City of Portsmouth Planning Board

Property Address: 806 Route 1 Bypass

Application #: LU 22-81

806 US Route 1 Bypass
Project Description

TITLE		
UTILITY PLAN		
806 US-1 BYP. PORTSMOUTH, NH 03801 TAX MAP 161, LOT 43		
JOB NUMBER	DWG. NO.	ISSUE
21-072	3 OF 7	8

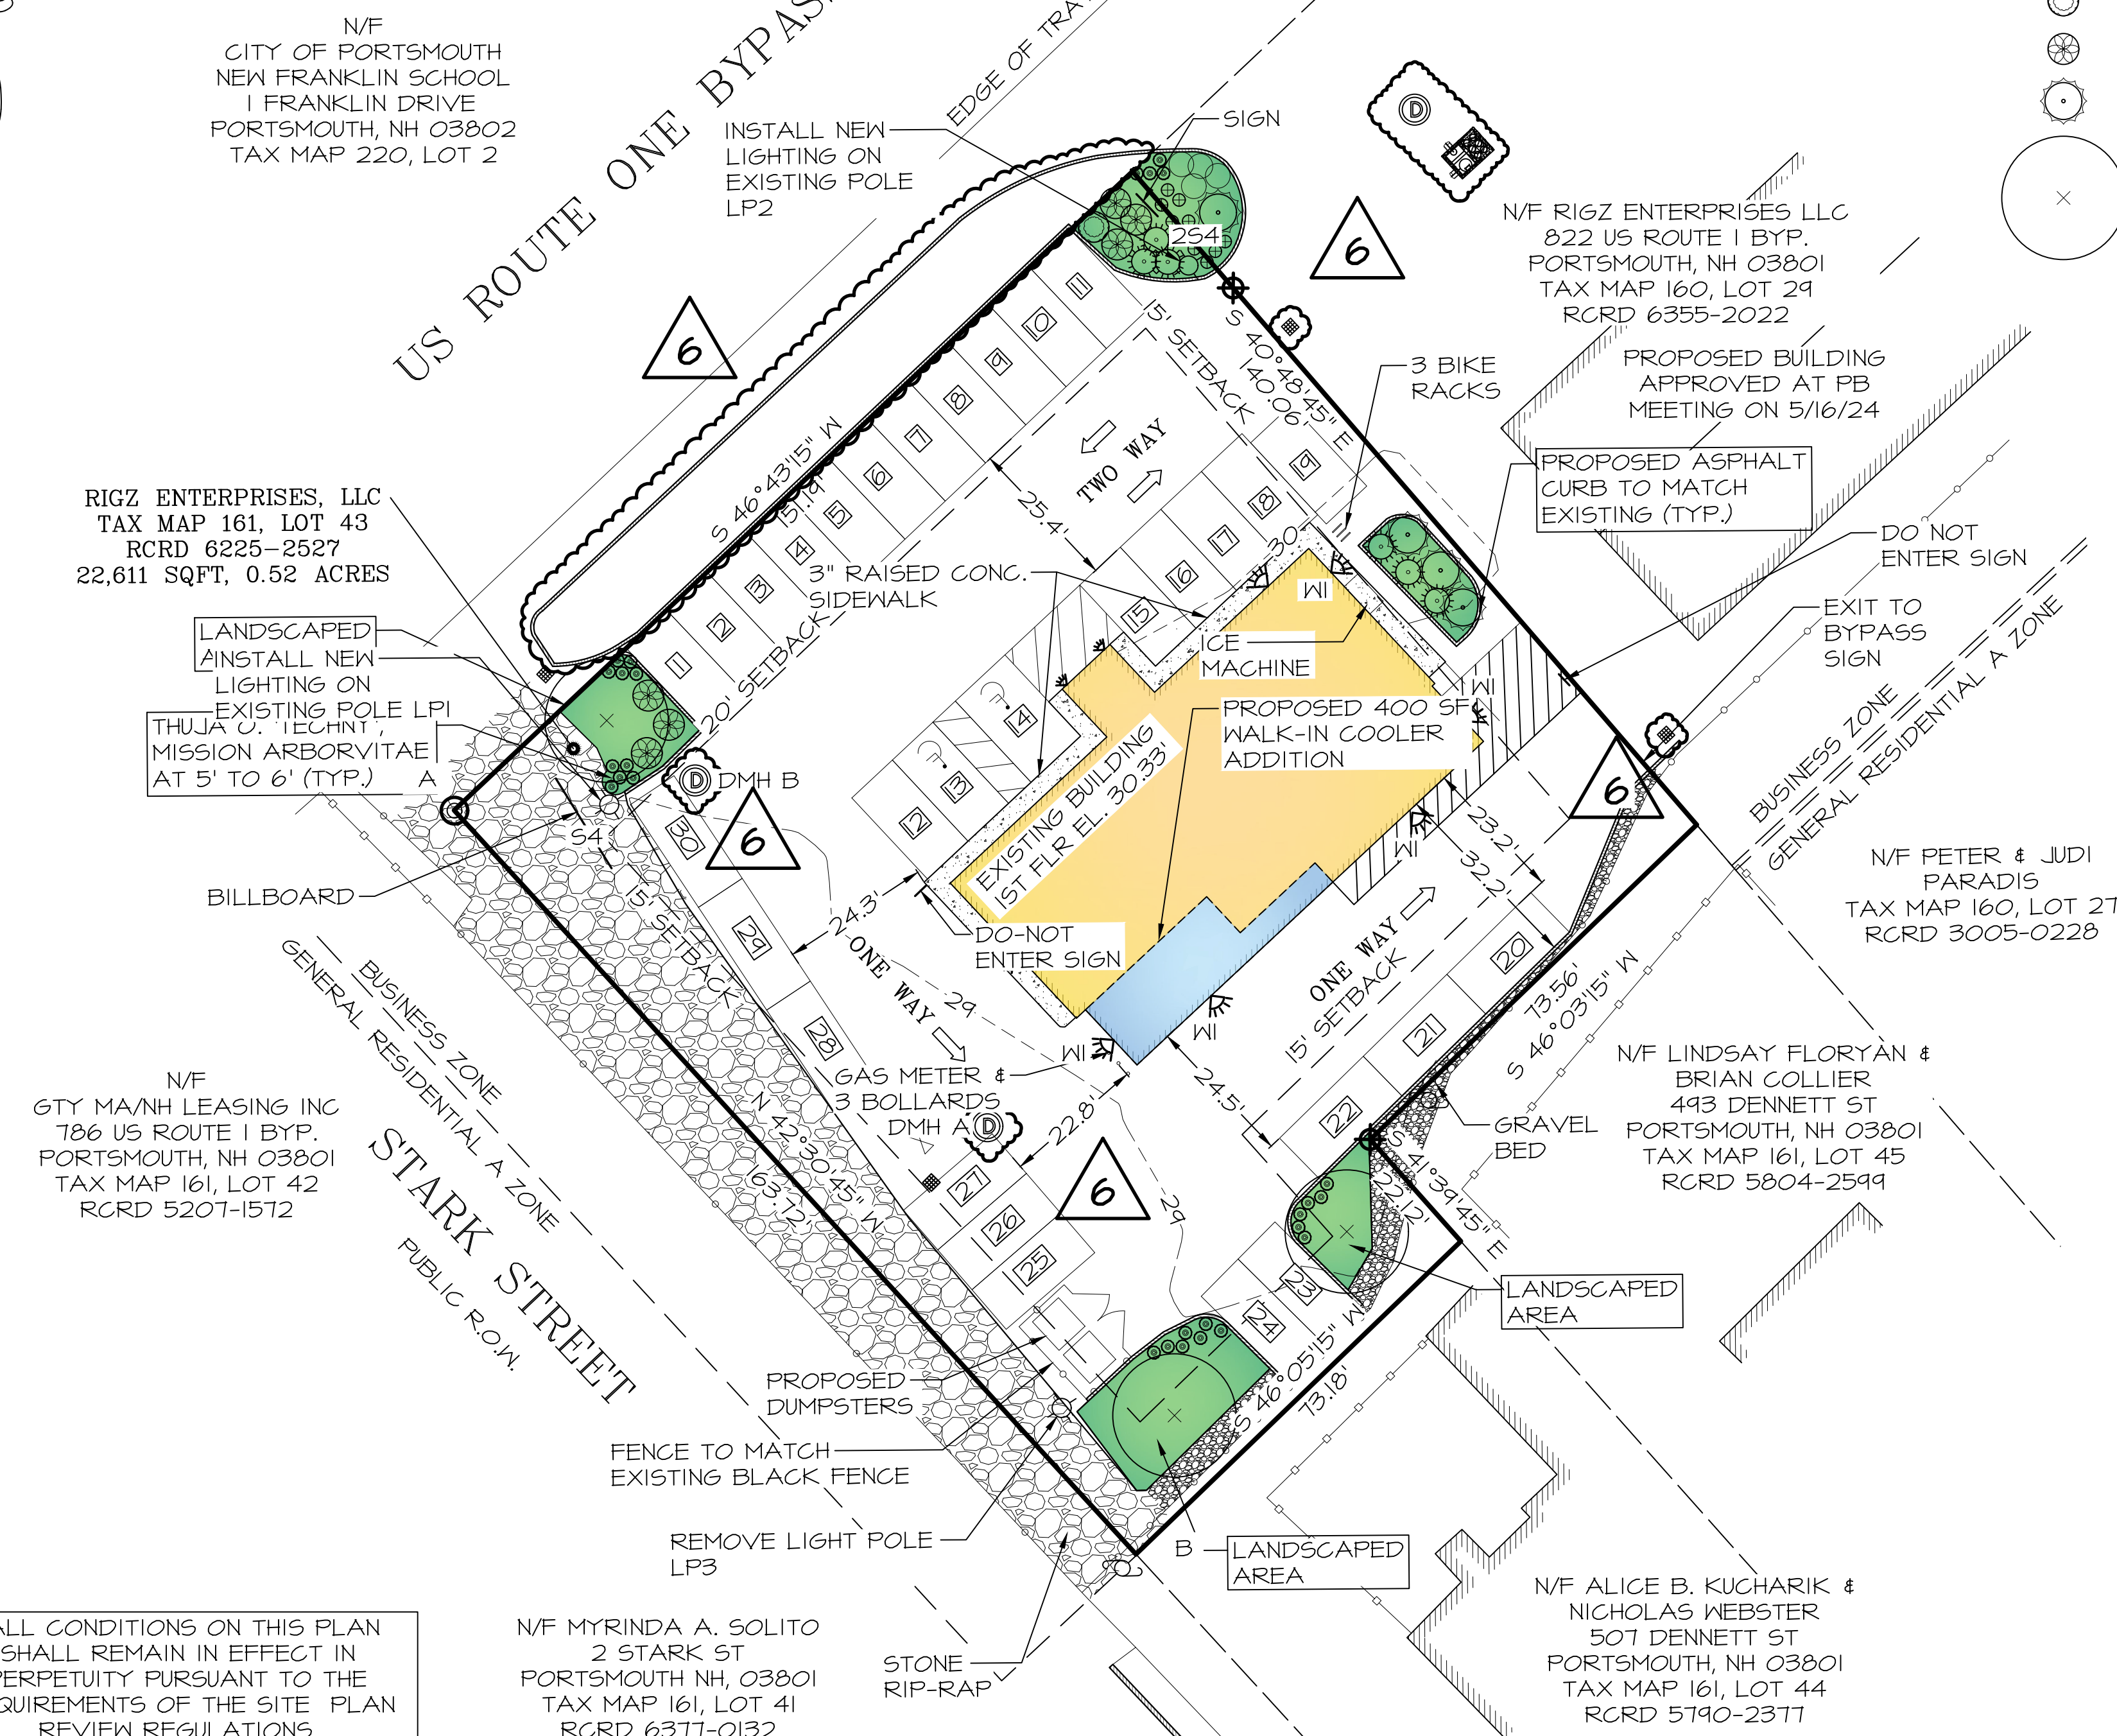
Drawing 3 – Utility Plan

- Landscaping removed in NHDOT right of way, as per NHDOT request. This is shown on drawings 2-4.
- Drainage has been changed to depict new proposed drainage system. New drainage system is depicted to match proposed drainage on lot 29, which is connected to drainage system on lot 43.
- Stormwater notes for drainage system on drawing 3 “Utility Plan”.
- Revised existing and proposed drainage structure elevations on drawing 3 “Utility Plan”.
- Revised lighting on drawing 3. Note 3 and the Lighting Specification Table have been revised. Lighting notes on the plan have been revised and are shown on drawings 2 & 3.

- LANDSCAPING REMOVED IN NHDOT RIGHT OF WAY AS PER NHDOT REQUEST
- DRAINAGE HAS BEEN CHANGED TO DEPICT NEW PROPOSED DRAINAGE SYSTEM. NEW DRAINAGE SYSTEM IS DEPICTED TO MATCH PROPOSED DRAINAGE ON LOT 29, WHICH IS CONNECTED TO DRAINAGE SYSTEM ON LOT 43.
- REVISED STORMWATER NOTES & FOR DRAINAGE SYSTEM.
- REVISED EXISTING AND PROPOSED DRAINAGE STRUCTURE ELEVATIONS.
- REVISED LIGHTING NOTE 3, LIGHTING SPECIFICATION TABLE AND LIGHTING CALL OUTS ON THE PLAN.
- REVISED PROPOSED UTILITIES SEWER NOTE 4.

The existing sewer service to Dennett Street will be disconnected and capped. Contractor to coordinate with DPW for the disconnection of the line. A note has been added to proposed utilities sewer note 4 on drawing 3 "Utility Plan".

TITLE
LANDSCAPE PLAN
806 US-1 BYP.
PORTSMOUTH, NH 03801
TAX MAP 161, LOT 43

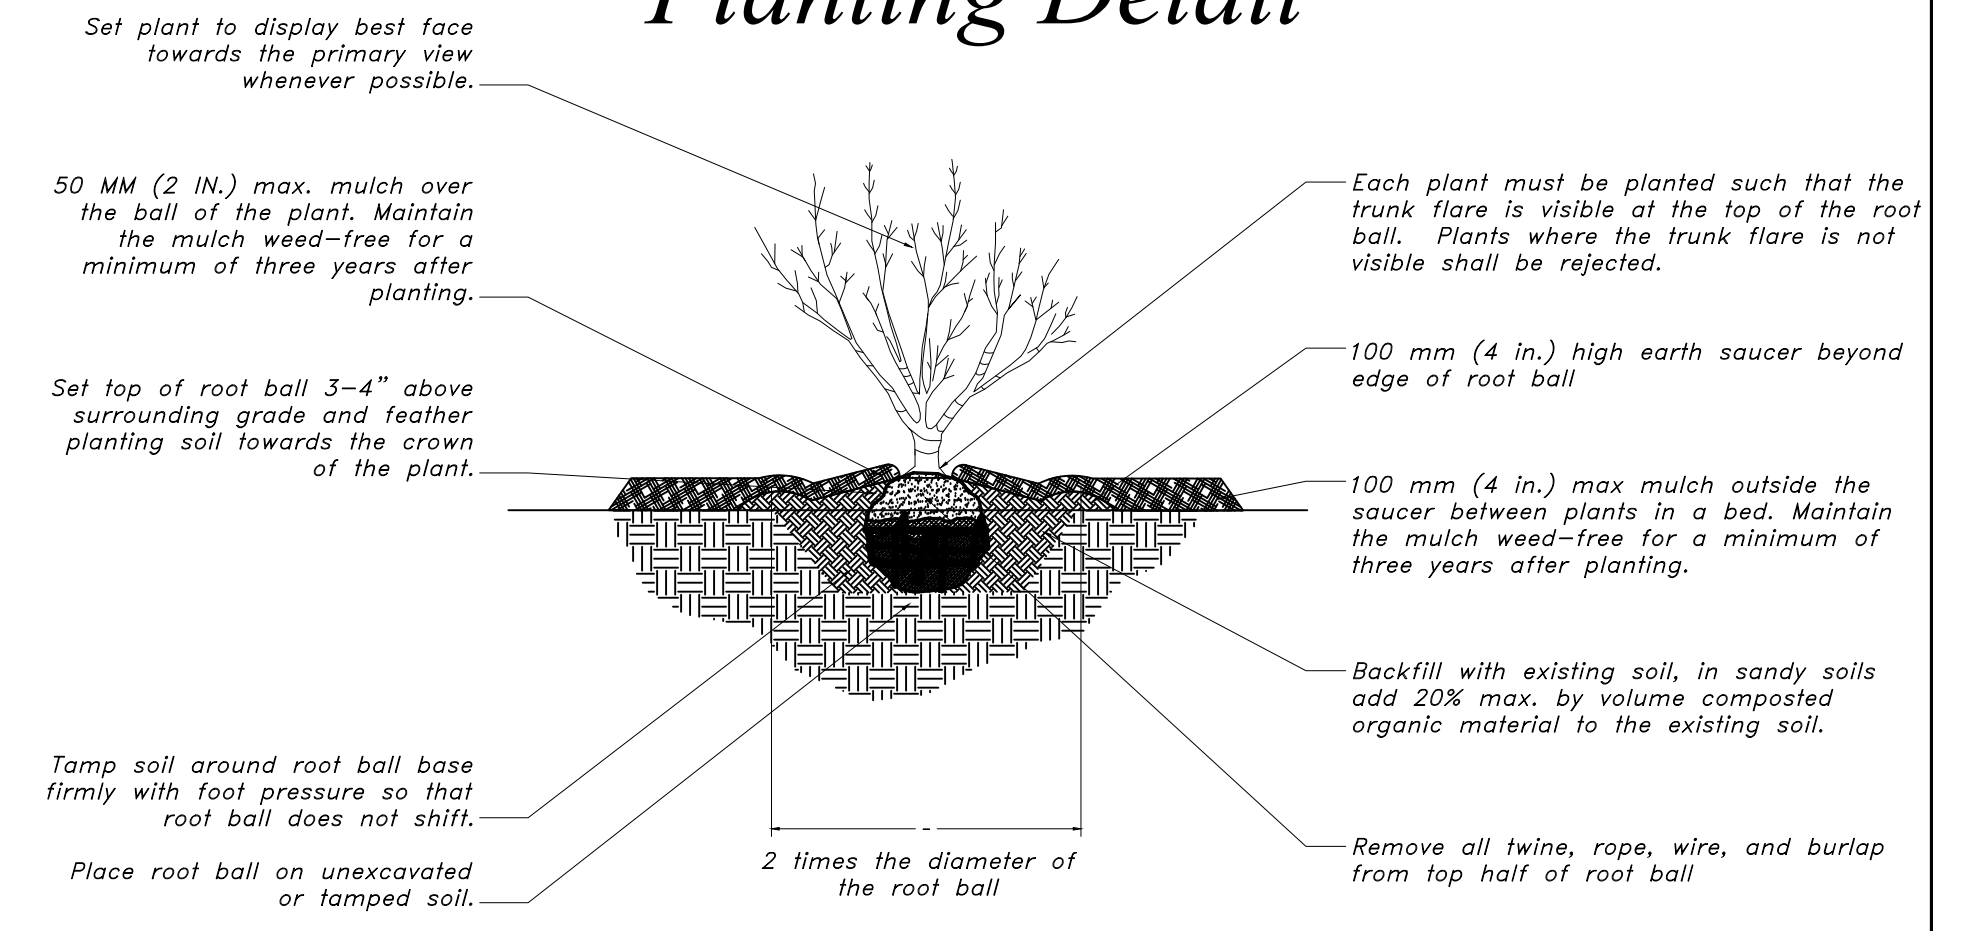
Drawing 4 – Landscape Plan

- Landscaping removed in NHDOT right of way as per NHDOT request.
- Drawing 4 “Landscape Plan” has been changed to depict new proposed manhole and catch basin locations.
- Planting notes have been changed to reflect landscaping that has been changed to reflect landscaping that has been removed in the NHDOT right of way.

- LANDSCAPING REMOVED IN NHDOT RIGHT OF WAY AS PER NHDOT REQUEST.
- LANDSCAPE PLAN HAS BEEN CHANGED TO DEPICT NEW PROPOSED MANHOLE AND CATCH BASIN LOCATIONS.
- PLANTING NOTES HAVE BEEN CHANGED TO REFLECT LANDSCAPING THAT HAS BEEN REMOVED IN THE NHDOT RIGHT OF WAY.
